Planning Commission Memorandum

Item: SUP and Site Plan – 2017-11 – large scale outdoor sales – 2980 Highway 61 S – Hastings Chrysler Center and St. Luke’s Episcopal Parish

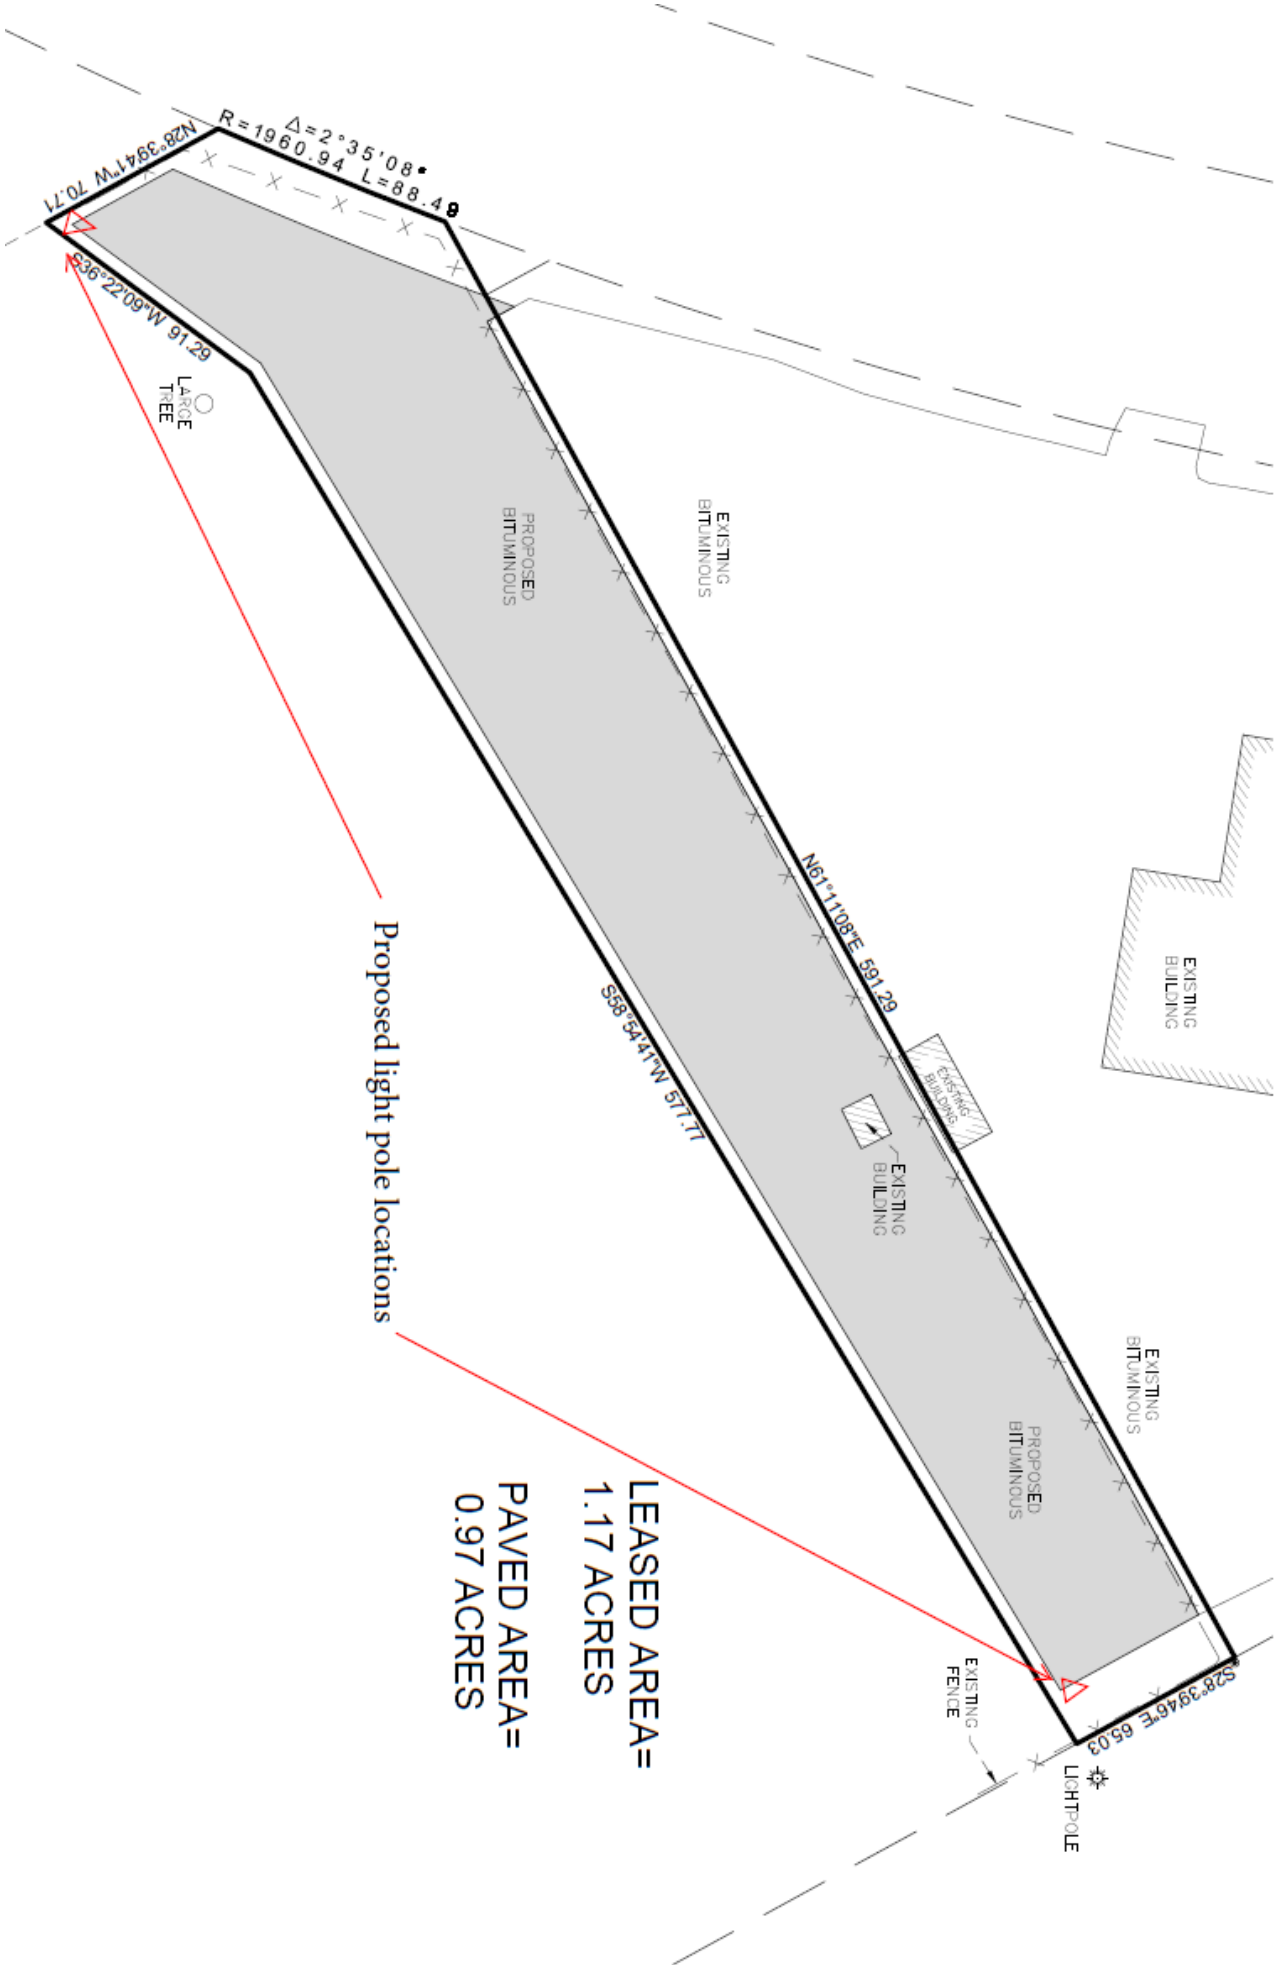
There is a 50-foot tall coniferous tree proposed for removal, which is within the proposed vehicle display area. The tree preservation policy allows for the removal of significant trees based on a replacement schedule.

Existing site lighting will be maintained with existing poles. Two new pole lights will be added in the area of expansion with similar poles and LED fixtures. A photometric plan for those two lights is expected to be completed next week.

The Engineering Department has reviewed the proposed plan and commented that one or more acre of soil disturbance will required additional storm water review. They are currently just under one acre of pavement. Additionally, curb and gutter is required for this project, as proposed.

- 1) Development in conformance with the Planning Commission Staff Report and plans dated April 24, 2017.
- 2) The applicant must gain MnDot approval of the proposed site plan and drainage.
- 3) If there is one acre or more of land disturbance, additional stormwater management requirements will be in effect.
- 4) Provide a photometric plan meeting ordinance requirements for additional lighting.
- 5) Approval is subject to a one year Sunset Clause; if significant progress is not made towards the proposal within one year of City Council approval, the approval is null and void.
